## **APPROVED MINUTES OF THE MEETING**

**November 6, 2008**

**November 6, 2008**      **Project:**      **Epiphany School Alley Vacation Part 2 – Public Benefit**

<b>November 6, 2008</b>	<b>Project:</b>	<b>Madison Valley Storm Water Improvements</b>
	<b>Phase:</b>	Schematic Design
	<b>Last Review:</b>	September 18, 2008
	<b>Presenters:</b>	Brent Middleswart, SPU Peter Nelson, Karen Kiest Landscape Architects
	<b>Attendees:</b>	Peter Triandafilou, Greater Madison Valley Community Council Celia Kennedy, SPU Grace Manzano, SPU Ruri Yampolsky, Office of Arts and Cultural Affairs

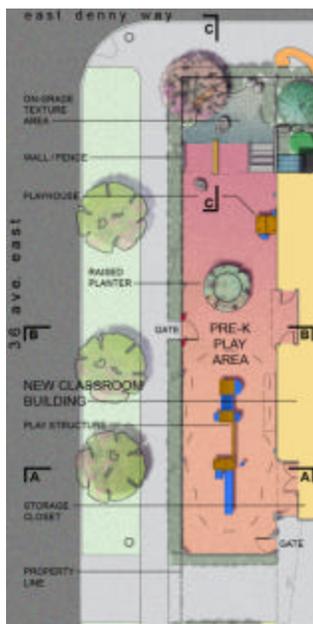
- Pleased to see the fence transparency around the pre-K play area, but some of the edges seem sharp. Encourages that some of the artistic details could be integrated into the fence and columns.

- Encourage reexamination of a more generous gate width.
- Understands the artist's desire to maintain integrity of art, and supports the desire to avoid it taking over the site; however, we encourage making small overall design moves in various site elements to strengthen its presence and to integrate the artwork more comfortably into the site and along the fence. The design should respond more to the artwork itself and support its presence on the site.

*There is greater transparency with the fence, but it still seems like a sharp edge. Can the framework of the fencing respond to the voluptuous art and landscape, especially on the awkward corner post?*

*How wide is the gate?*

*A wider gate would be more inviting to the public.*

It is four feet wide.

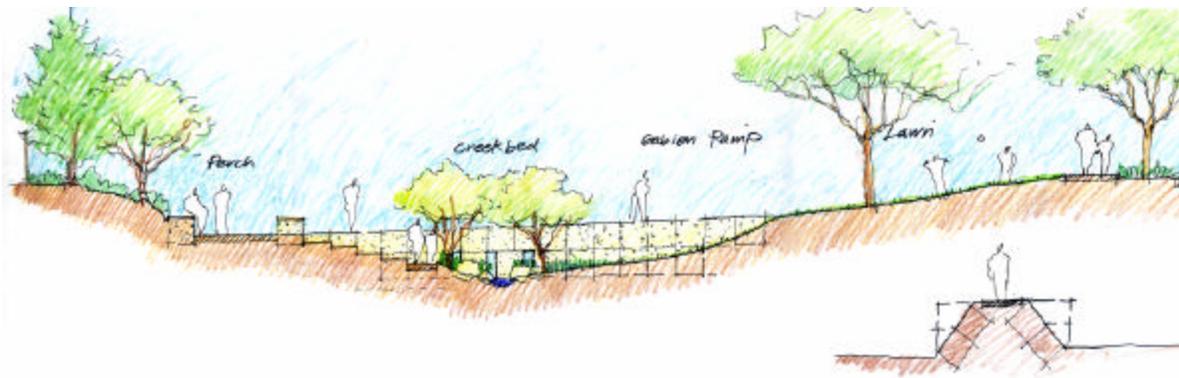
*Is the gabion bridge intended to address ADA slope issues? Does it divide the site in half?*

*The gabions are an interesting idea; perhaps they could be more playful.*

*The five foot gabion height may be a concern; three-and-a-half to four feet may be preferable.*

Yes, it is a response to ADA constraints. It is also an opportunity to create a bridge and dramatic topographic interest.
